NON CONFORMANCE REPORT

Non conformance Record Number	NCRN002
System	AMICA Star Tracker
Subsystem	ASTC - AMICA Star Cracker Camera
Part Name	
Part Number	240.001
Serial Number	001
Problem Description	The cable ASTC-ASTE (244.610) does not provide a stable connection on the ASTC side. The connector shows a mechanical interference with the the fasteners on ASTC-side due to the ASTS_CONNECTOR_PLATE height that increases the nominal bolts height by approximately 1mm. See drawings on next page.
Proposed solution	Reduce 25 pin - MR75-80-25-S-1-B-P (244.623) bolts height by 1 mm.

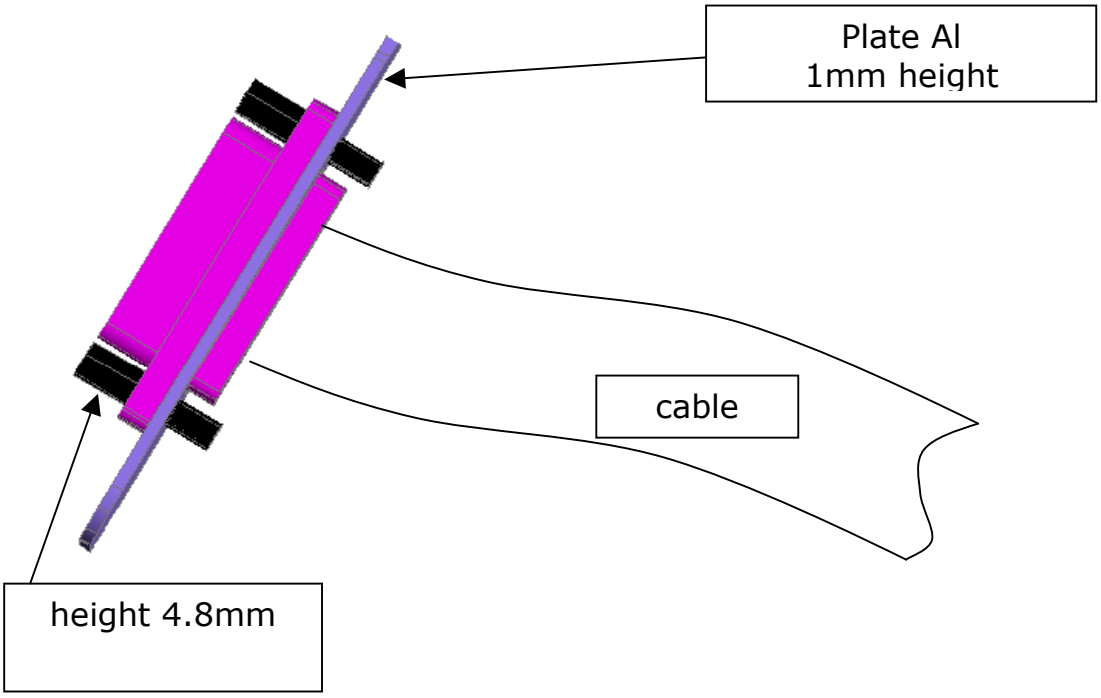
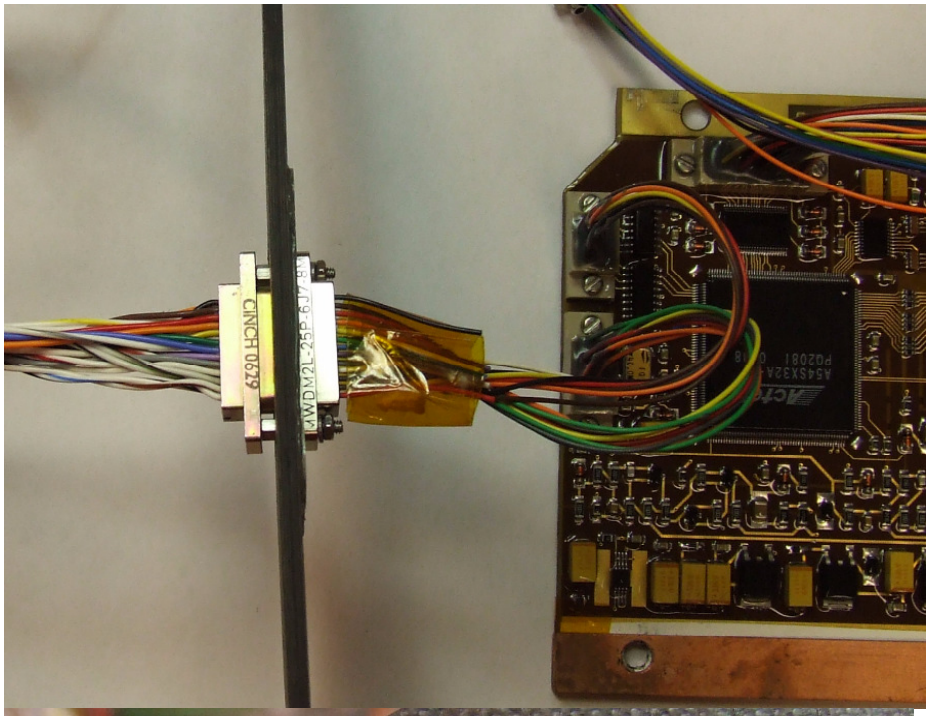
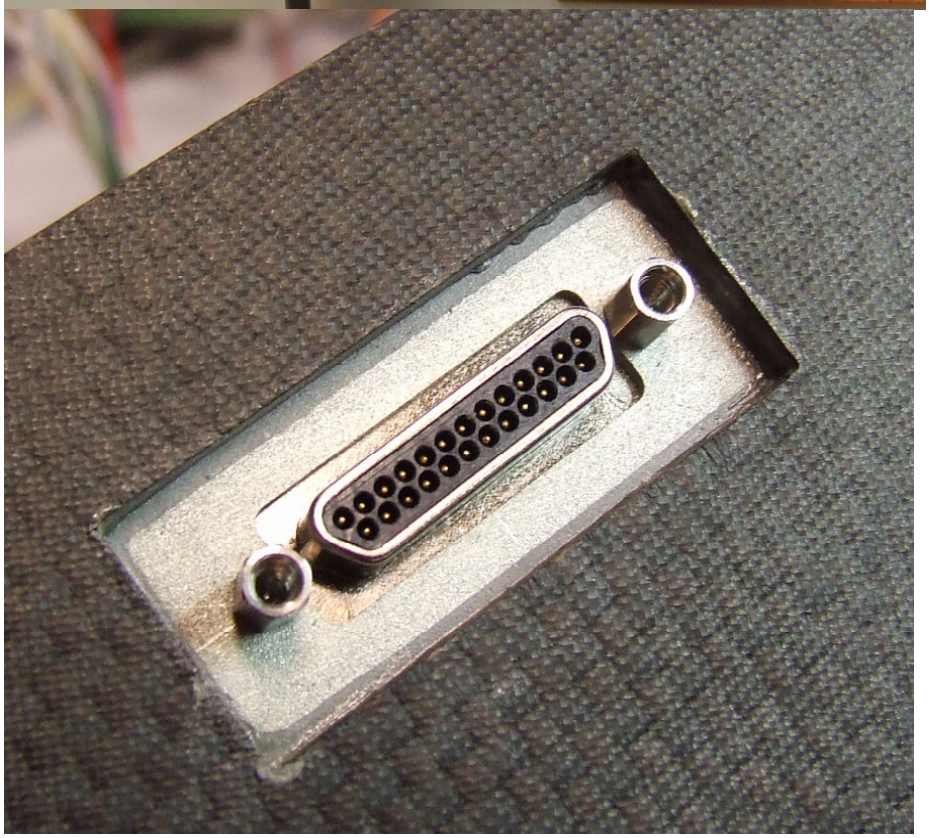
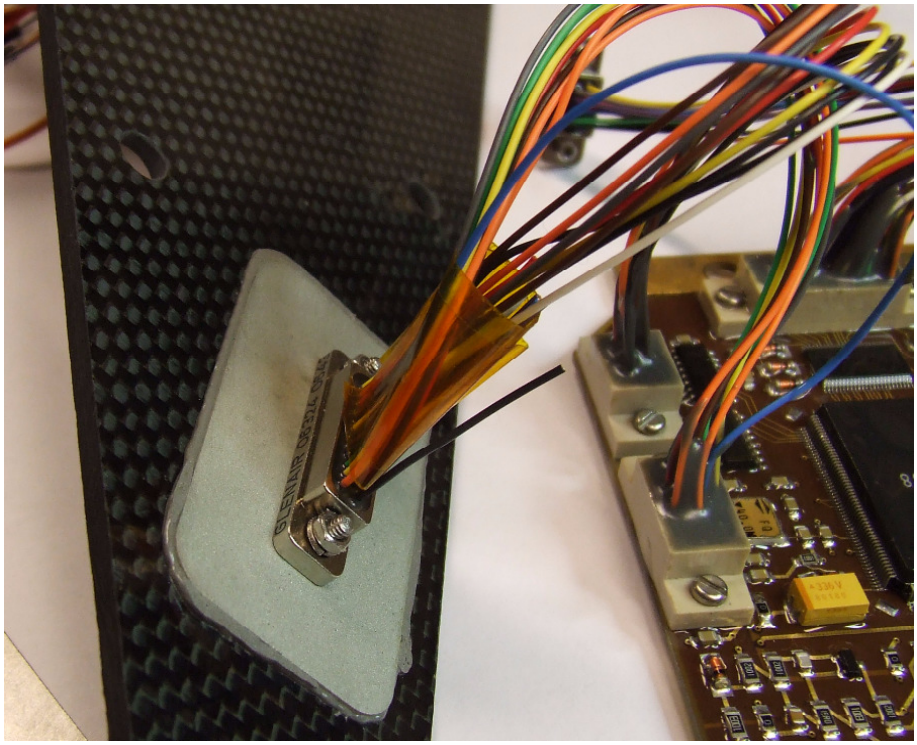
The correct connector assembly is not viable due to the cable termination on PCB (soldering ang potting already performed). As a consecuence, the connector is mounted as in the pictures, behind the plate. This is why the bolts height is increased with respect to the standard. To compensate the difference in height, the bolts have to be smaller (replace or rework is needed).
